PRODUCT BULLETIN

Trunnion Profile Change

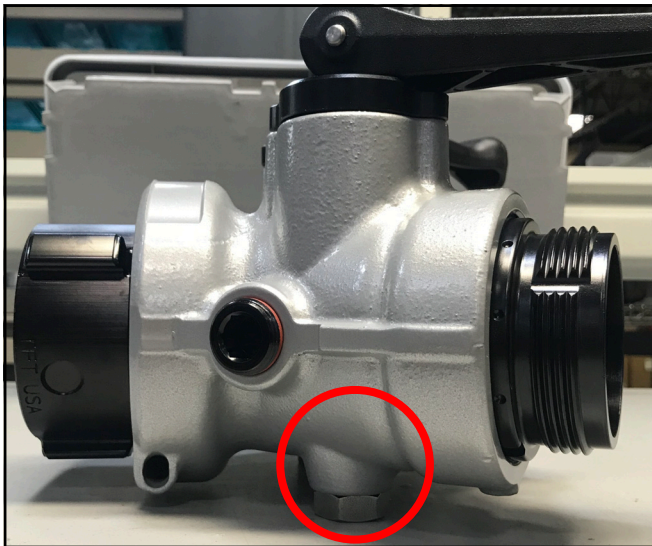
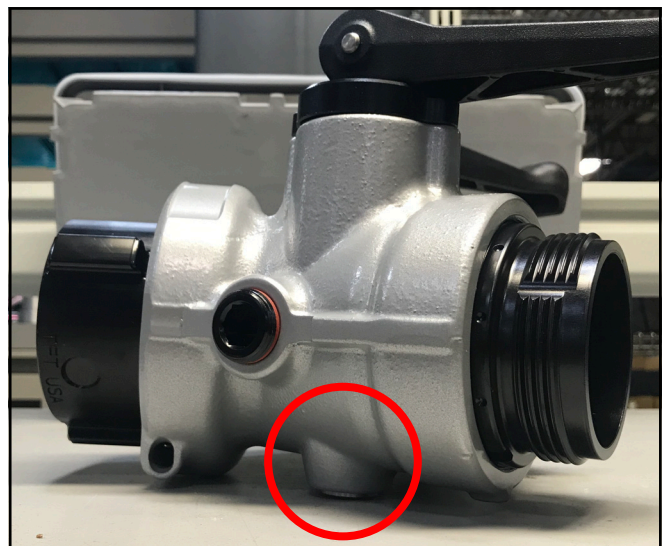
A design change has been made to replace the Hex Head Trunnion with a Low-Profile Internal Hex Trunnion.

This change affects 2.5" Valves, Water Thief, Hi-Rise Valves, HUM, VUM, Gated Wye, Gated Siamese, and Hemisphere monitors. The 2.5" Gated Wye is shown as a representative example.

**PREVIOUS DESIGN
THROUGH 7/2021**

**UPDATED DESIGN
AFTER 7/2021**

Features and Benefits	
Fit and Finish	More compact
Reduced Length	Will not snag
Materials	303 Stainless Steel (same as the previous design)
